July 14, 2016

Re: **Chesterfield Power Station – Response to Technical Comments for Groundwater Monitoring Plan – Solid Waste Permit SWP 617**

**RESPONSE TO COMMENTS – DEQ LETTER DATED FEBRUARY 26, 2016  
UPDATED GROUNDWATER MONITORING PLAN  
CHESTERFIELD POWER STATION, UPPER ASH POND  
CHESTERFIELD COUNTY, VIRGINIA**

DRAWING 2

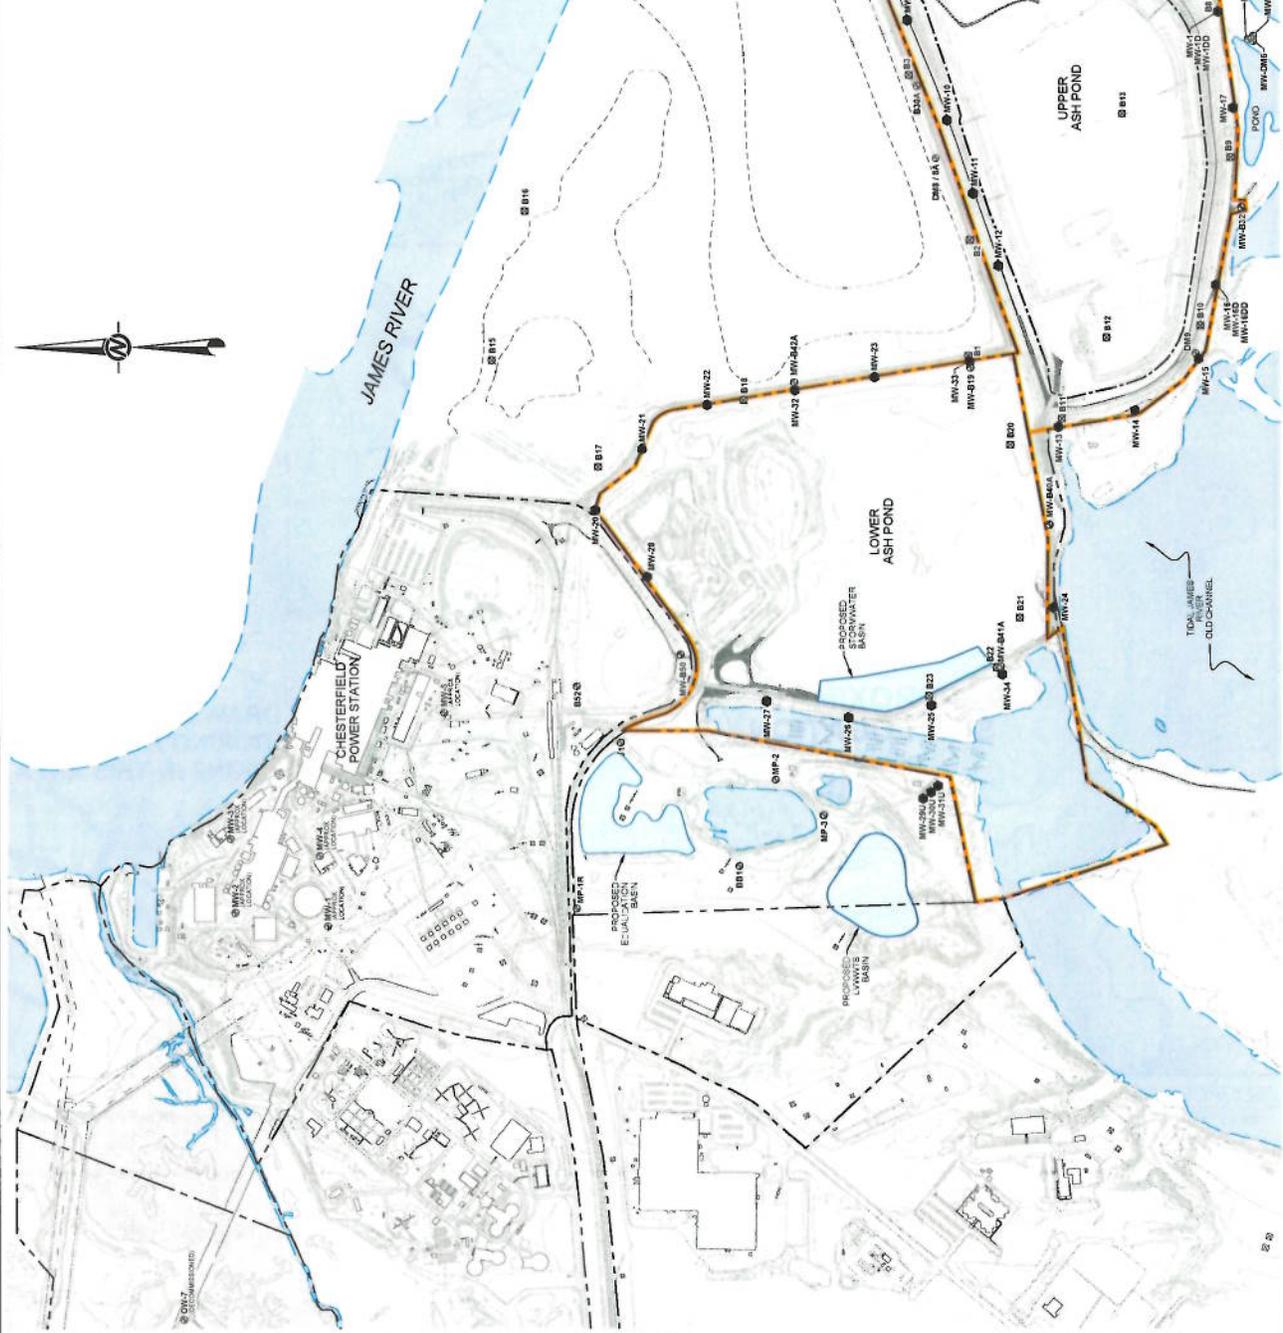
- 6. Drawing 2 depicts some of the proposed down-gradient monitoring wells potentially between the toe drain and the waste mass. No groundwater monitoring wells should be located between the toe drain and the waste mass.*

14. *Drawing 2 should depict the edge of surface water.*

Dominion has adjusted most well locations to place the wells on the outside of the toe drain where site conditions will allow. It is noted that wells MW-7 through MW-12 are located inside of the toe drain on Dominion property. These locations were selected for health and safety, well security, and well access reasons. Specifically, the toe drain in this area of the site appears to be located off of Dominion property. Drawing 2 has been updated to illustrate the updated well locations.

As requested, Drawing 2 of the Plan has been updated to clearly illustrate the approximate mean high water line for the James River, as well as other water bodies in the project area.
